Hamilton City Council
Private Bag 3010
Hamilton 3240
New Zealand

17 July 2018

Rotokauri North ICMP: Desktop Review of Hydrogeological Conditions Influencing Stormwater Design

Figure 1: Rotokauri north development area concept stormwater layout (CKL, 2017)

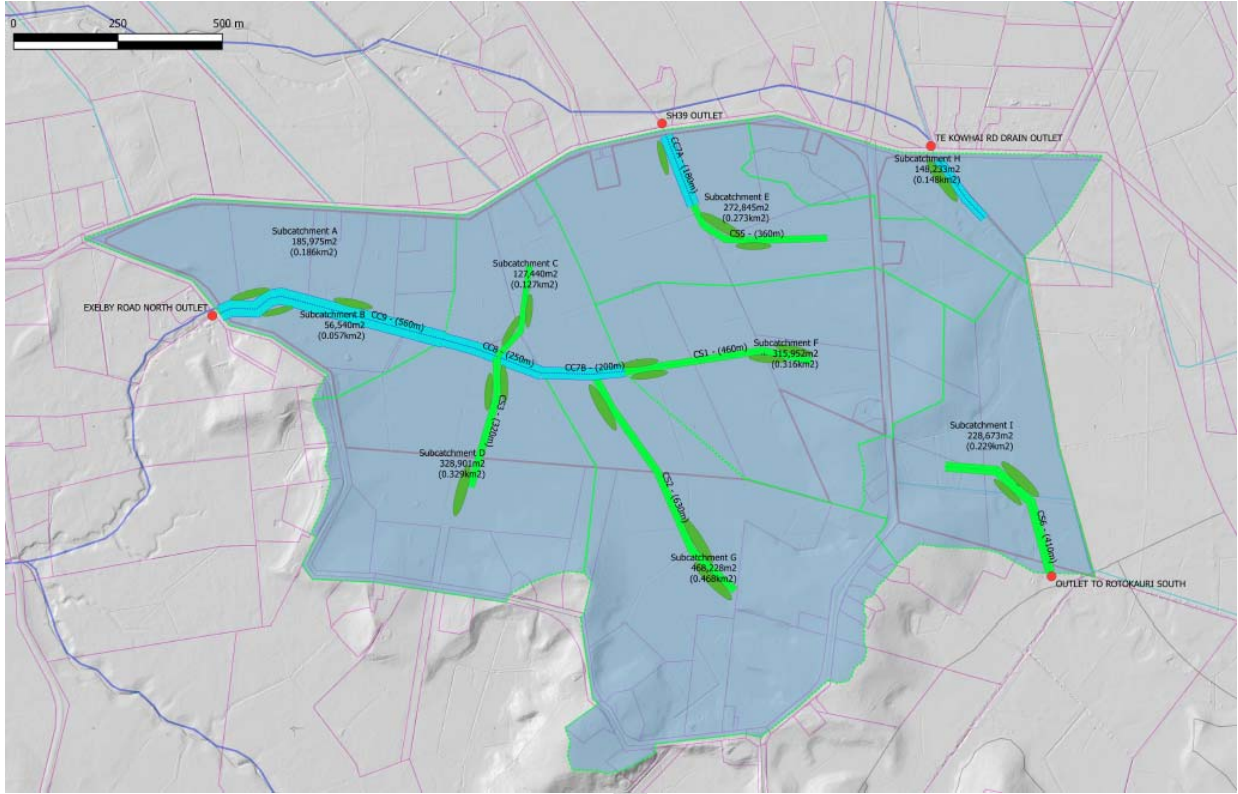
The preferred concept option has been identified as a central drain / green corridor (Figure 1). The typical depth of the channel is intended to be 2 m. It is proposed in the center of the corridor, a relatively small main channel (26-30 m wide) will support permanent base-flows in a run-riffle-pool type arrangement, with the wider corridor (53-76 m wide) profiled to accommodate larger events, similar to that outlined for the overarching Rotokauri ICMP.

A central drain / green corridor has been identified as the preferred option. The corridor is nominally 50 m to 70 m wide with a maximum depth of 2 m. Where storage basins are required they are likely to be largely accommodated within the corridor footprint (to the scale shown in Figure 1).

Initial (short duration) results from the high level feasibility investigations indicate a winter groundwater level that is a maximum of 1.1 m bgl, but in locations as high as 0.1 m bgl with a direct response to rainfall. Levels could be higher after large rain events such that the water table is likely to be encountered at or close to ground surface in some locations. This may locally constrain the maximum achievable unlined channel (or basin) depth. If an unlined basin or channel extends below the groundwater table in places, part of the storage will be taken up by groundwater which may drain from a wider area up-gradient.

Figure 4: Simplified sketch (not to scale) indicating a typical Conveyance Channel, geological profile, groundwater level and potential drawdown.

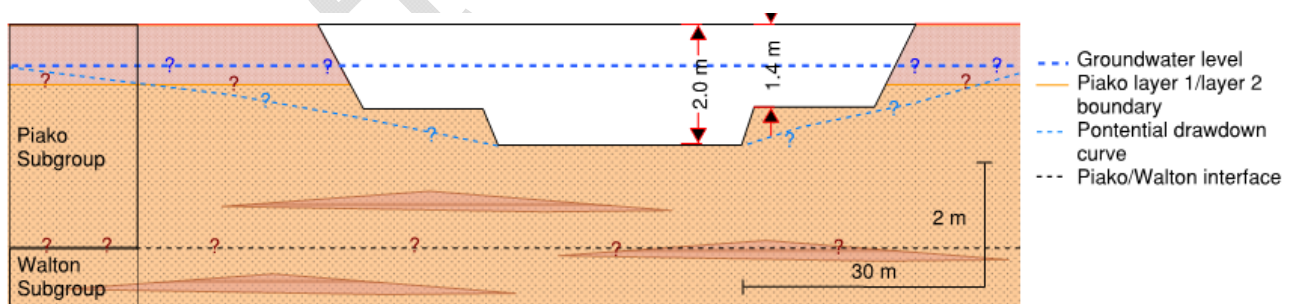
With the preferred stormwater conveyance channel option in mind, and the existing publically available data it is possible to draw some high-level assessment of potential constraints and opportunities relating to stormwater management. A typical cross section summarising this information is seen in figure 4.

Where excavations are required below the groundwater table, drawdown (as shown on Figure 3) could occur with the potential for:

- Groundwater drawdown induced consolidation settlement. This is a risk in areas where excavation of the waterway will encounter sandy materials that are located below the ground water level. In this situation the channel could drain groundwater from further away causing settlement of the overlying compressible soils. The risk of settlement to neighbouring structures requires further consideration as the need to limit drawdown may be a constraint on the maximum depth of cut.
- Loss of channel or storage basin capacity. If the channel is unlined, some of the volume would be taken up by groundwater; if it is lined then upward groundwater pressures would need to be considered in design.
- Groundwater drawdown could affect surface water bodies, however, our desktop study has not identified any significant natural surface waterbodies.

Figure 5: Indicative (approximate) locations showing ideal piezometer locations relative to the concept catchment plan. Note: the locations shown have not taken into account any real-world / logistical restrictions that maybe encountered on site.

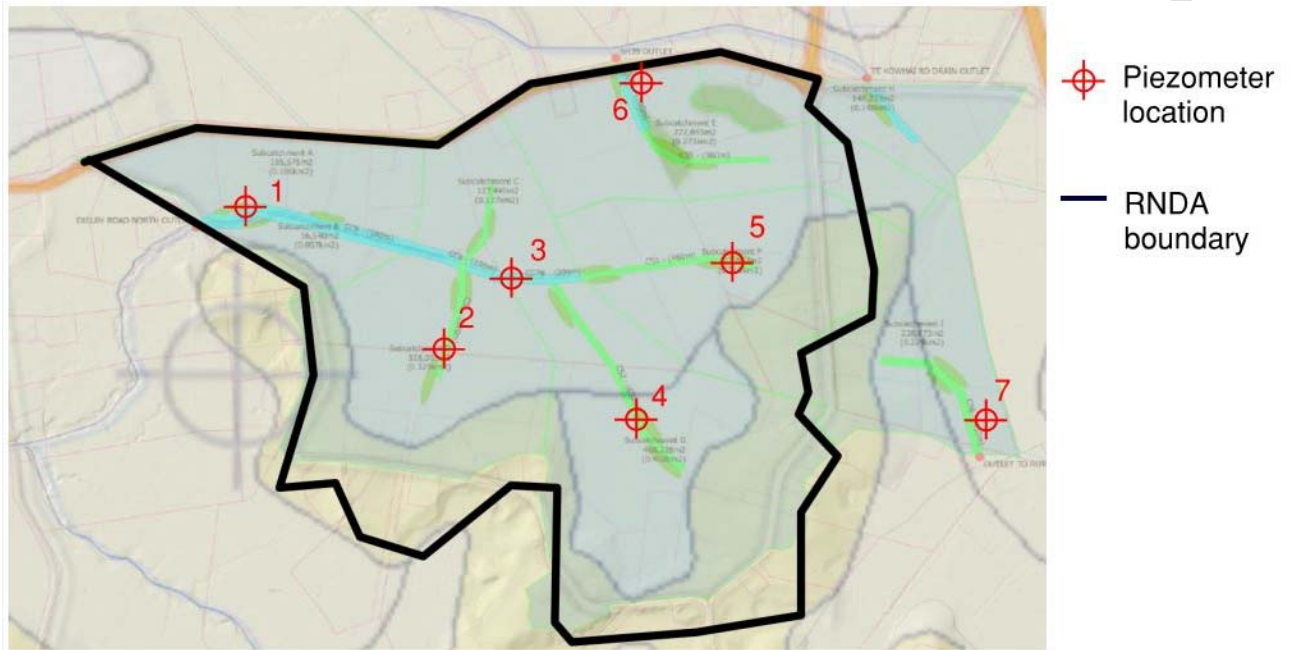
Indicative locations for the confirmatory site investigations are shown below (Figure 5).

Boreholes should be completed as piezometers screened at or just below proposed excavation depth and would comprise a minimum of 1 piezometer at each of the locations shown above in order to assess local variability (particularly where the wetland / basin areas are large). It would also be prudent at a selection of locations to install a deeper piezometer immediately adjacent to confirm if the shallow water table identified in the recent investigations is perched. Each site is likely to take 1 – 2 days to drill and complete at an estimated contractor cost of \$2,500 per day (not including any geological logging).
